THIRD FLOOR PLAN
 1:100

APECA Certificate of Authorization CH2M HILL Canada Ltd. No. 1441 Expiry: April 30, 2006	 Frederickson Cooper ARCHITECTS		 A Terra International Ltd. Company		ENGINEER'S SEAL ORIGINAL SIGNED BY D. KRUGER 2006/02/06	 THE CITY OF WINNIPEG WATER AND WASTE DEPARTMENT ENGINEERING DIVISION WATER TREATMENT PLANT OZONE FOUNDATIONS AND CONCRETE STRUCTURES STRUCTURAL OZONATION AREA THIRD FLOOR PLAN	CITY FILE NUMBER SHEET OF
	DESIGNED BY MH CHECKED BY AP	DRAWN BY RL APPROVED BY DJT	SCALE: 1:100 RELEASED FOR CONSTRUCTION BY: R. SOROKOWSKI		CONSULTANT DRAWING NO. WO-S0131		CITY DRAWING NUMBER 1-06010-A-S0131-001-01D
	NO. REVISIONS 01 583-2005 ADDENDUM 3 06/03/10 MH 00 ISSUED FOR TENDER 06/02/03 MH	DATE BY 2005/07/07	DATE 2006/02/08

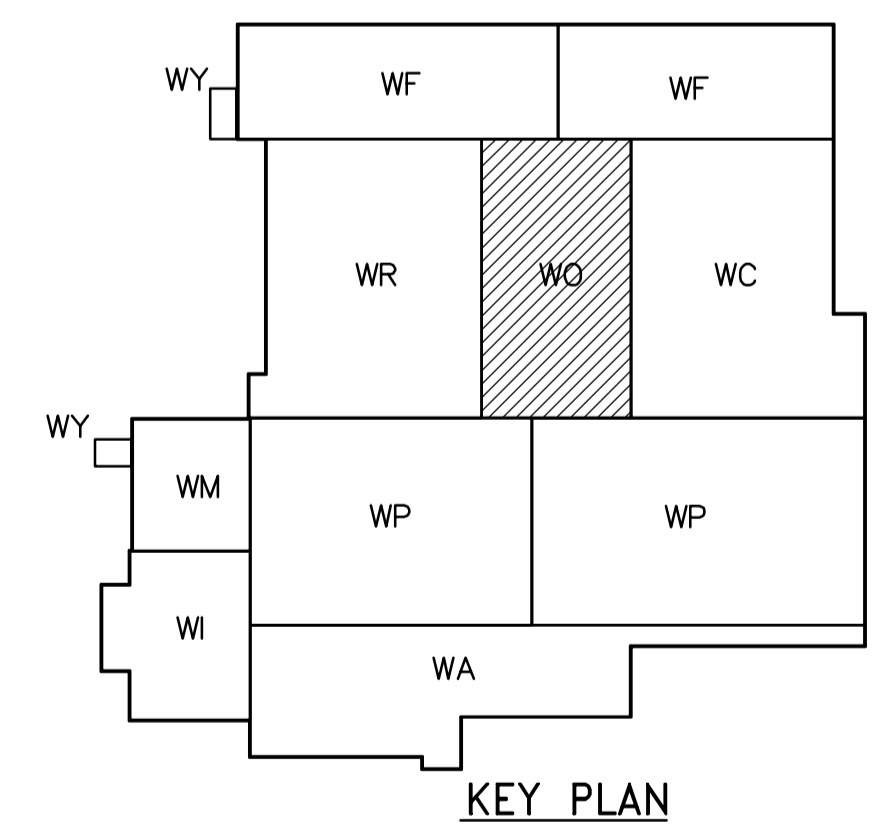
△01 BACKGROUND HIDDEN LINES REVISED OR SHOWN FOR CLARITY
